Decision 29226-D01-2025

Fox Meadows Wind Inc.

Fox Meadows Wind Project

Proceeding 29226

Figure 2. Project area and whooping crane migration corridor

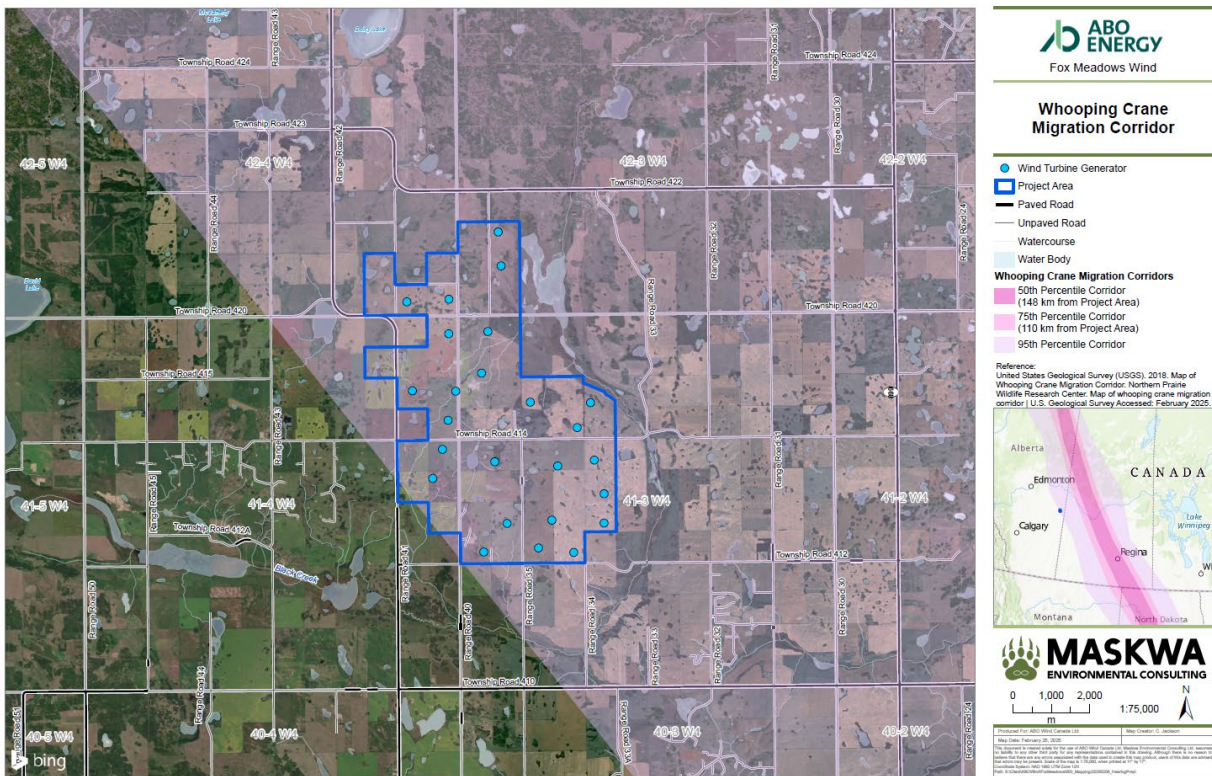
54. Submissions in C. Wallis’s evidence included a figure showing historical records of whooping crane near the project area. However, the Commission noted that concentrations of observations were primarily east of the project, and areas of extended use were absent in Alberta, with the exception of their breeding grounds in northern Alberta.<sup>26</sup> The Commission requested an undertaking for geospatial maps which showed the likelihood that whooping crane would travel through the project area. A map was submitted to the record which showed that the project was located in the 95th percentile corridor, meaning that 95 per cent of the population travelled within the bounds of this area (see Figure 2).<sup>27</sup>

55. In the Commission's view, it is important to explain Figure 2 for clarity. Instead of interpreting this figure as showing that 95 per cent of whooping cranes will travel through the project area, it is important to consider the 50th percentile corridor and 75th percentile corridor in conjunction with the 95th percentile corridor. As a whole, this figure is showing that a majority of the population migrates in a concentrated corridor east of the project, with a very clear focal point through Saskatchewan and northern Alberta, and occasionally individuals will stray from this concentrated migration corridor towards the 95th percentile corridor. However, as distance from the 50th percentile corridor increases, population stray becomes less likely.

- a. Fox Meadows Wind Inc. shall submit an annual post-construction monitoring survey report to Alberta Environment and Protected Areas no later than January 31 of the year following the mortality monitoring period and submit the annual post-construction monitoring survey report and Alberta Environment and Protected Areas' post-construction monitoring response letter to the Commission within one month of its issuance to Fox Meadows Wind Inc. These reports and response letters shall be subsequently filed with the same time constraints every subsequent year for which Alberta Environment and Protected Areas requires surveys pursuant to Section 3(3) of Rule 033: *Post-approval Monitoring Requirements for Wind and Solar Power Plants*. Post-construction monitoring must include a survey of the power lines and transmission lines that service the project and are located within any percentile of the whooping crane migration corridor.

- c. All overhead power lines and transmission lines will have strike diverters, or additional superior mitigations, installed with the intention of avoiding whooping crane collisions. Fox Meadows Wind Inc. must ensure that a mitigation plan, which specifically addresses transmission line collision risk for whooping crane, is submitted during the future application for the transmission line associated to the project, and Alberta Environment and Protected Areas must be informed of, and provided a copy of, this mitigation plan.
